THE APPLICATION OF SUPRON ENERGY  
CORPORATION FOR A DUAL COMPLETION

ORDER NO. MC-2819

Re: Supron Energy Corp. U.S.A. #1 P-24-32N-13W

RE: Your letter dated 12/19/80  
Supron Energy Corp./John H. Hill  
Farmout Well U.S.A. #1  
P-24-32N-13W Mesa Verde/Dakota Dual  
and our C-107 Application

JOHN H. HILL ET AL

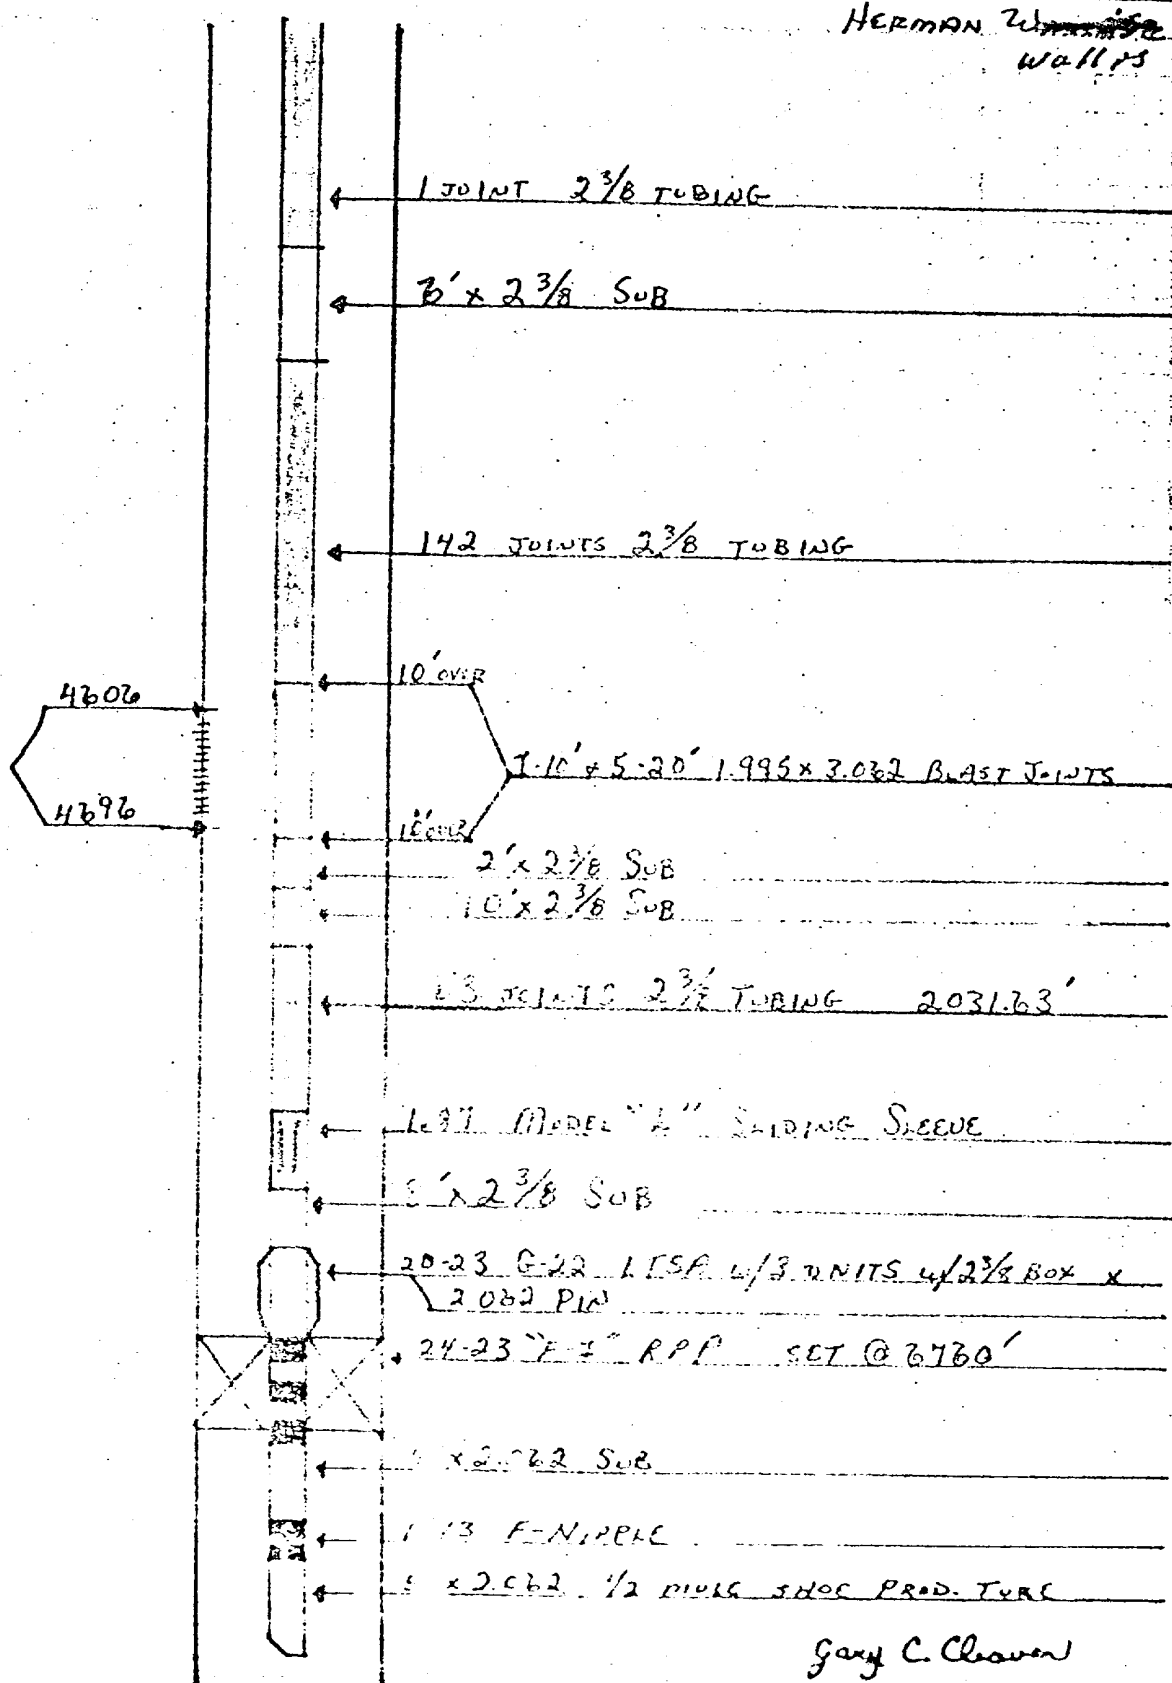
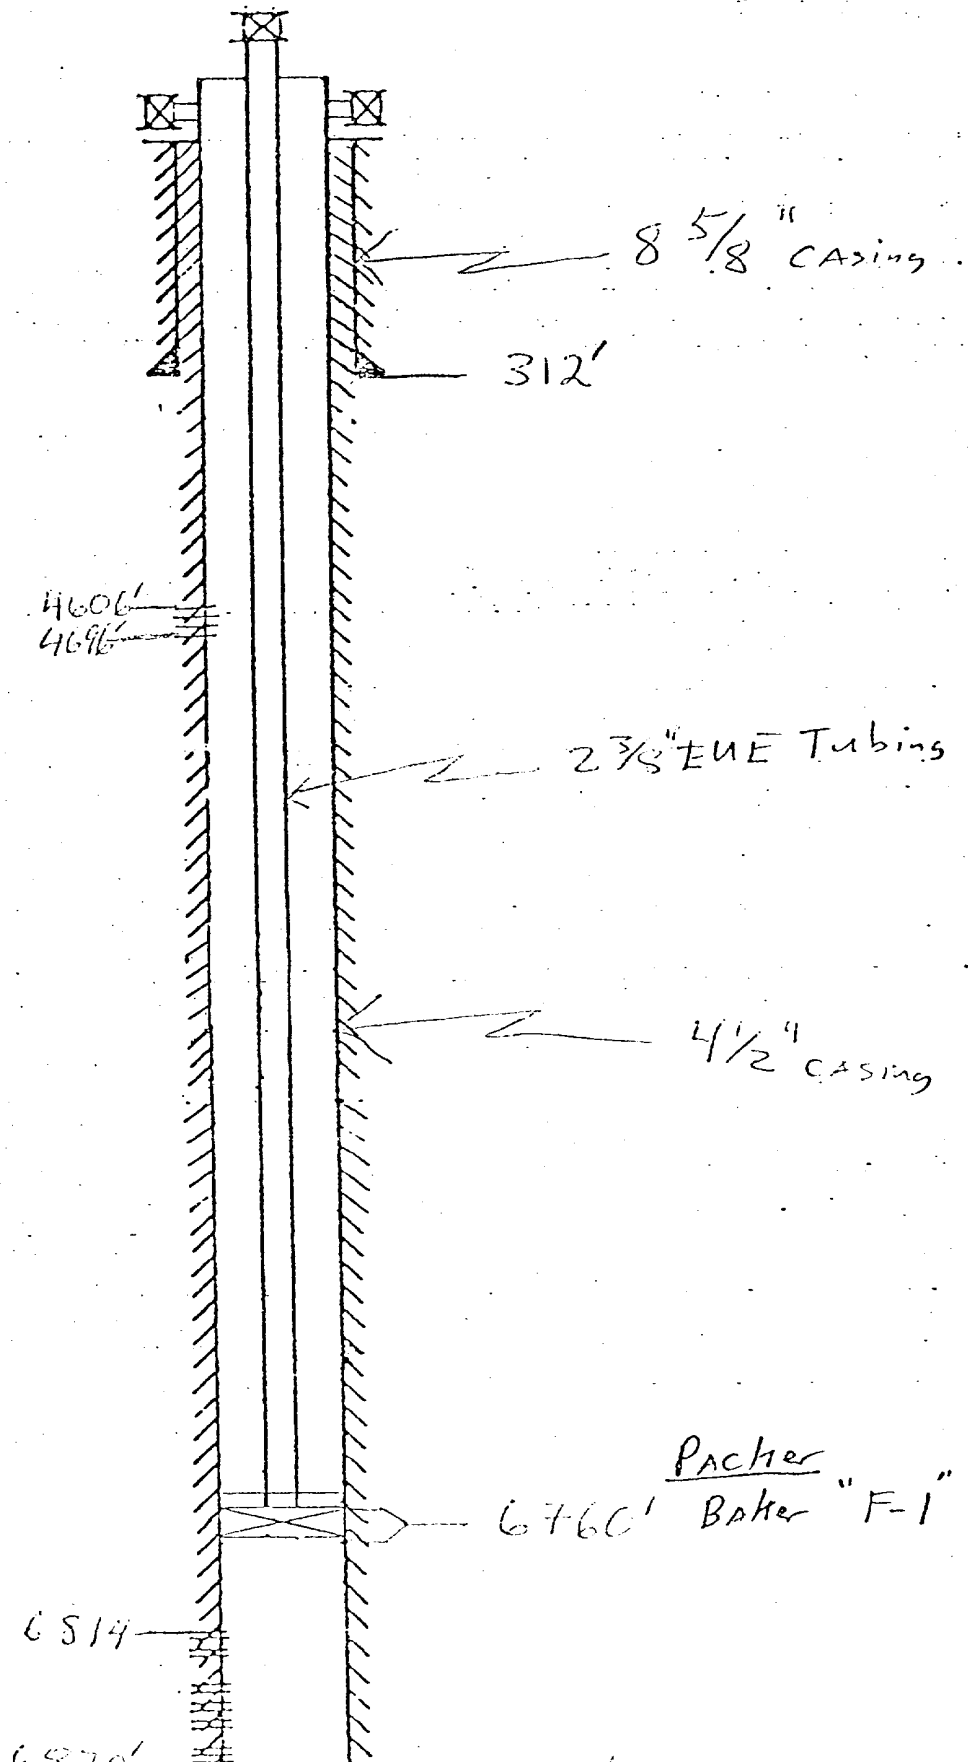
We have received your application for multiple completion of the referenced well. Before we can make a recommendation to the Director for approval we need more information regarding the efficiency of producing the Mesaverde formation up the annulus of this well.

Please submit data such as well tests, projected volumes of gas and liquid production, and such other data as will show that liquids will not accumulate in the well bore causing inefficient production.

Also, as tubing we ran 2-3/8" EUE 8 rd. Above the packer, we installed a Baker Model L "Sliding Sleeve" which can be opened and closed easily by a wireline tool (see attached sketch). The purpose of the sliding sleeve was mainly for efficient production. If significant fluid build-up has occurred to impair efficient production, then the operator shall make application to the Commission to open by wireline the sliding sleeve, thus "flushing" the annulus by unloading any Mesa Verde fluids with Dakota gas which is at a higher pressure. Commingling of gases should only be for less than a few hours per flushing.
